Consumers
Power
Company

MIDLAND PROJECT -
ALAB-106 MONTHLY REPORT FOR JANUARY 1981
DOCKET NOS 50-329 AND 50-330
FILE: 0.4.6 UFI: 70*01 SERIAL: 11196

In accordance with Condition of Memorandum and Order ALAB-106, dated March 26, 1973, and Amendment No 1 of the Midland Plant Construction Permit, enclosed are ten copies of the following documents written or closed during the month: Bechtel Nonconformance Reports, sheets from the Bechtel Nonconformance Report Log; Bechtel Quality Action Requests; Bechtel Management Corrective Action Reports; Babcock & Wilcox Reports of Nonconformity; B&W ISI NCR's; and Consumers Power Company Nonconformance Reports, Audit Finding Reports, Quality Action Requests, and Corrective Action Reports.

#12 TIE PLATE

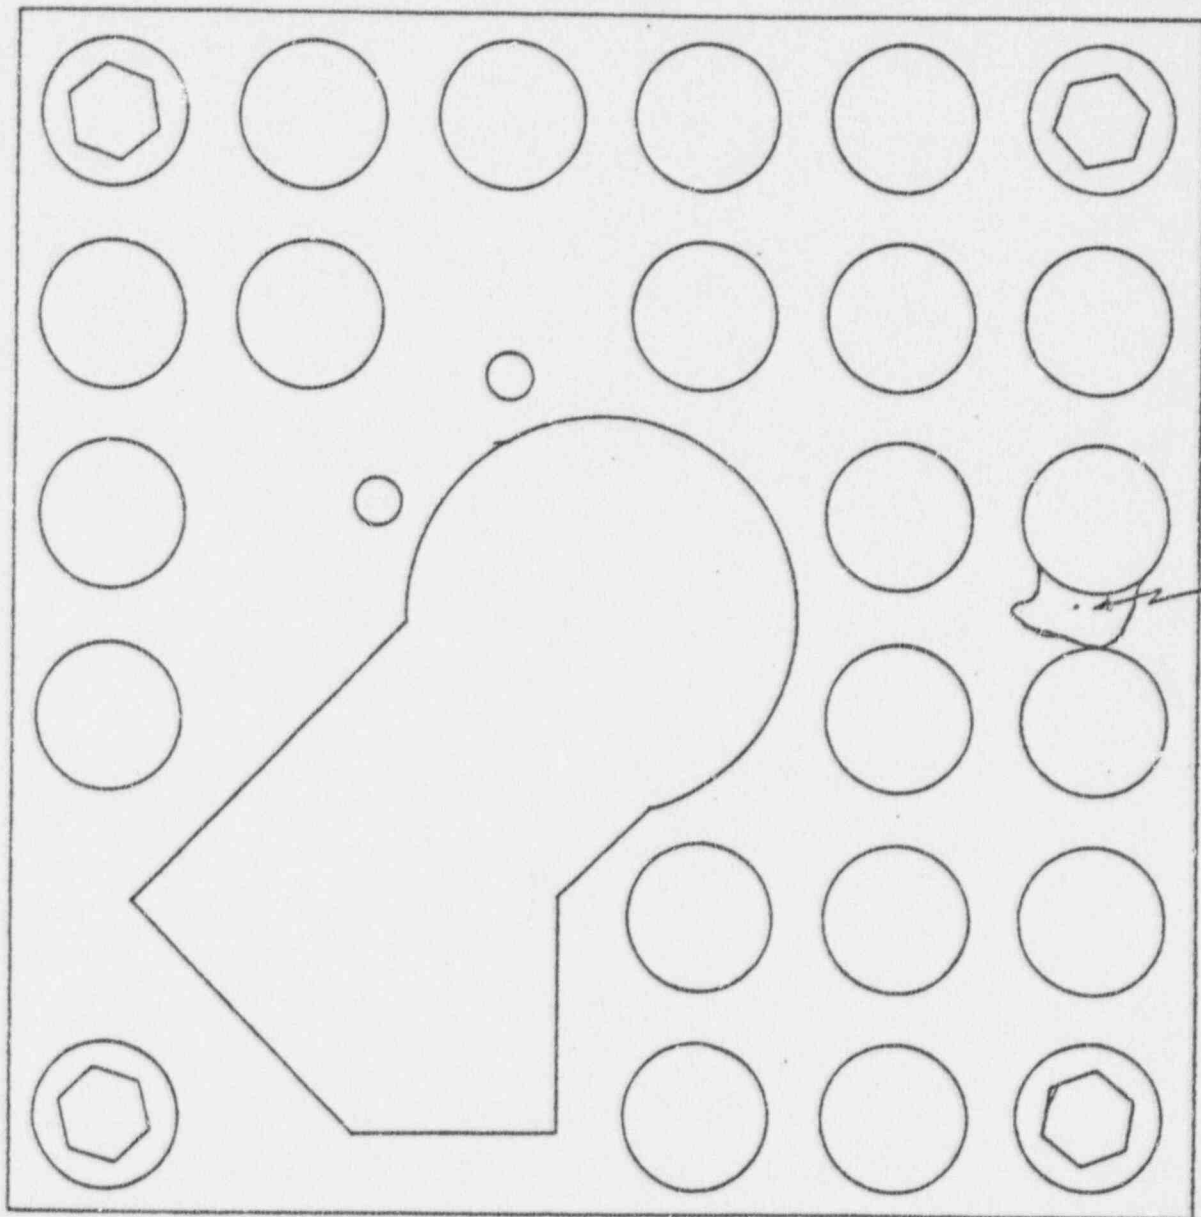
9. PROCEDURE NUMBER FCP #102		10. SPECIFICATION NUMBER N/A		
11. DRAWING NUMBER 203269E, Rev. 1		12. PRIOR REPORT OF NONCONFORMITY# N/A		
13. DESCRIPTION OF NONCONFORMITY An arc burn was created by a short in a welding cable at the edge of a hole in tie plate #12. (See sketch on Page 2 of 2).

ARC
BURN
LENGTH $1\frac{1}{2}$ "
WIDTH $\frac{1}{4}$ "
DEPTH $\frac{3}{32}$ "

2-611-1-11 WEST CORE FLOOD-UNIT #2

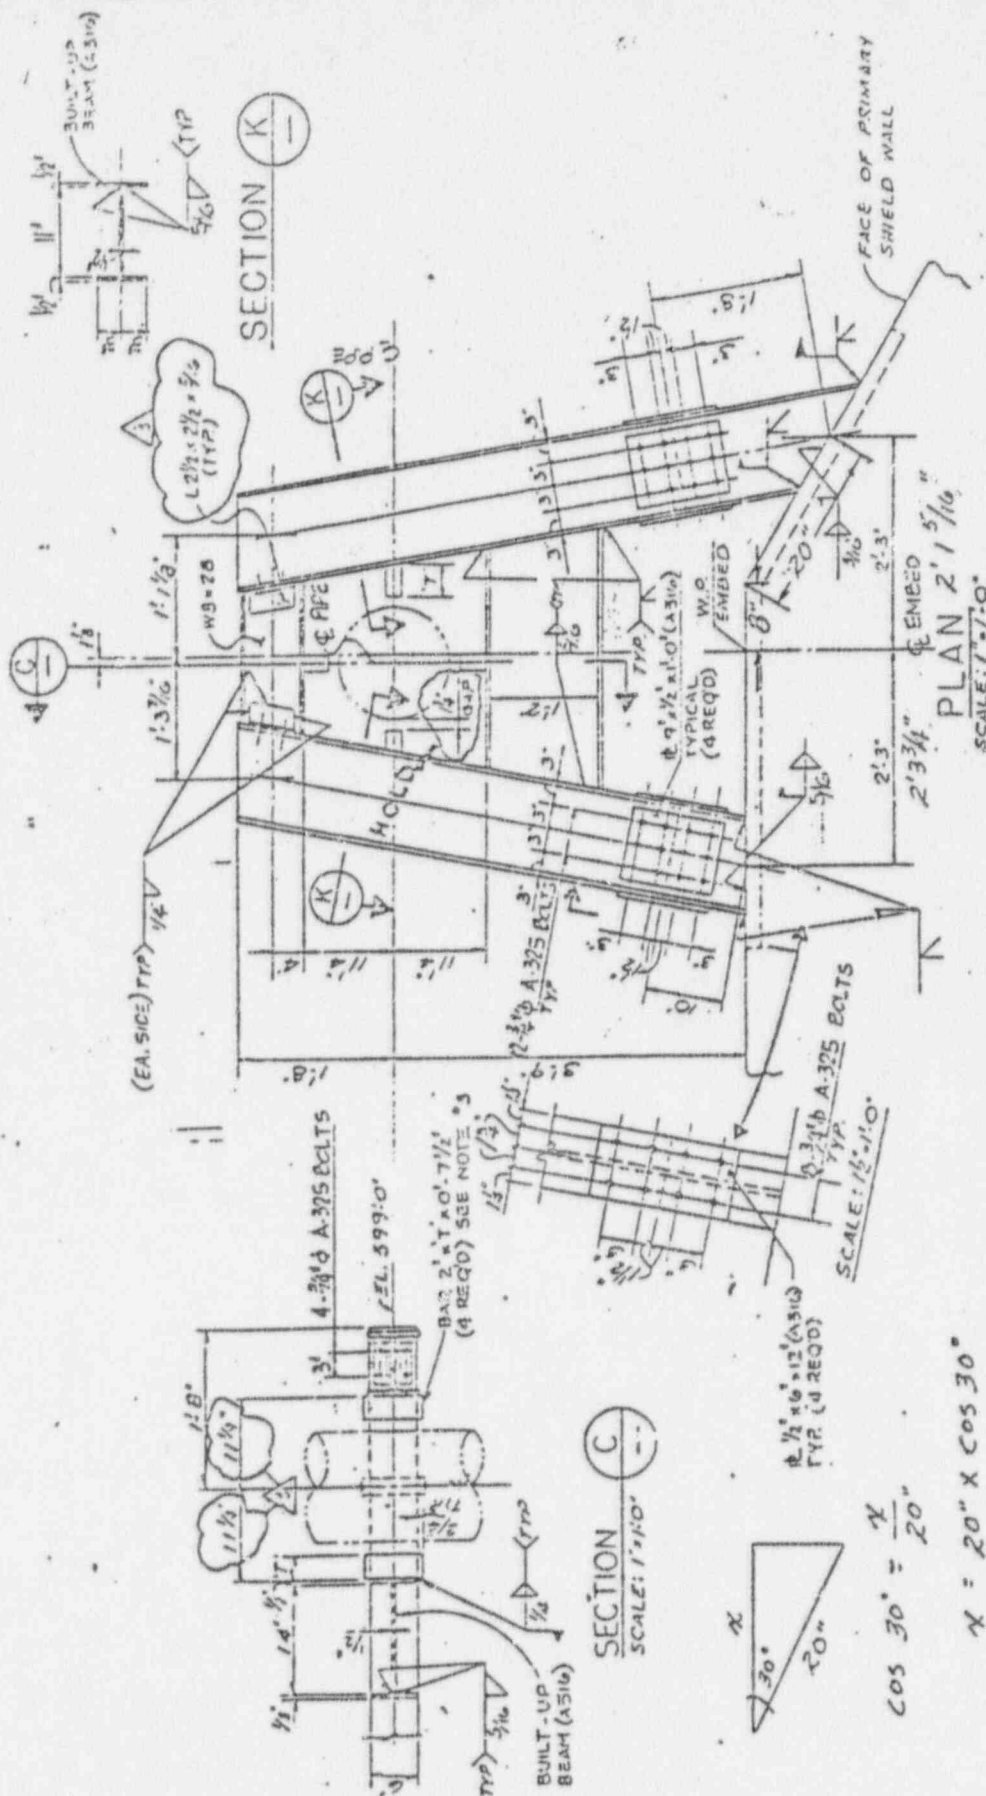
Project Engineering has reviewed FER CC-117 which requests a review of B&W NCR 1719. We have determined that all restraints except 2-611-1-10 (Type 35) may be accepted as installed. Restraint 2-611-1-10 requires the addition of stiffener plates to both horizontal members of the restraint as shown by the detail on the attachment. Project Engineering will revise Dwg. C-487 to show this detail.

21. DISPOSITION INSTRUCTIONS See RFI 378. Accept location as is. Restraint 2-611-1-10 will be revised in accordance with FCP 74A when Drawing C-487 is revised for additional stiffeners. <u>H. H. Lin</u> <u>6-9-80</u> FIELD PROJECT ENGINEER DATE
